PCN Number: 1319
Chgnot.doc rev. 13 1/14

Product/Process Change Notification (PCN)

**Customer Part # and/or Lot# affected: A3213ELHLT-T
A3214ELHLT-T**

Package Outline Comparison

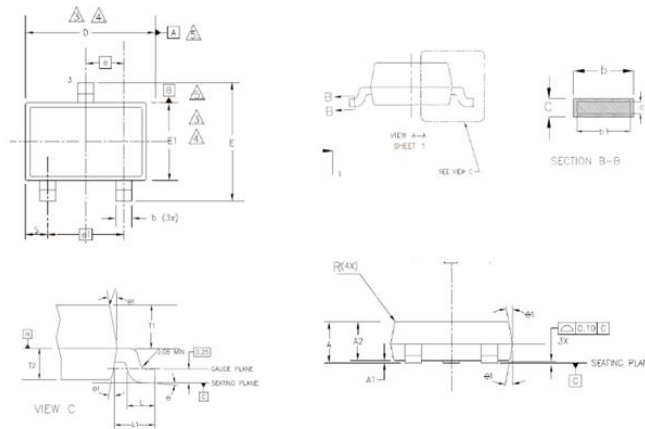
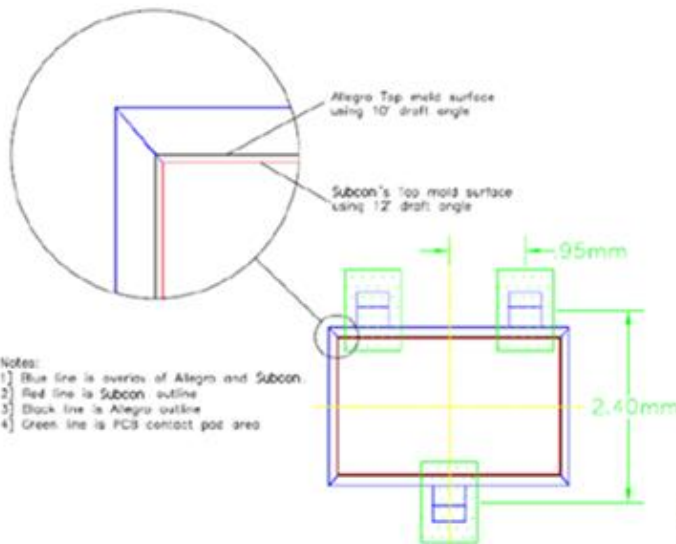
Min	Nom	Max	Min	Nom	Max
A	0.87	1	1.13	0.87	1	1.13
A1	0	0.05	0.15	0	0.05	0.15
b	0.3	0.4	0.5	0.3	0.4	0.5
c	0.127	0.18	0.2	0.127	0.18	0.2
D	2.895	2.975	3.1	2.9	2.975	3.1
E	2.7	2.9	3.0	2.7	2.9	3.0
E1	1.85	1.91	2.1	1.85	1.91	2.1
e		0.95			0.95 bsc	
e1		1.90 bsc			1.90 bsc	
AAD	0.24	0.28	0.32	0.24	0.28	0.32
S		0.55 Ref			0.55 Ref	
R				0.05	0.15	0.2
Foot Angle	0	4	8	0		8
Draft Angle		10 ref		10	12	14
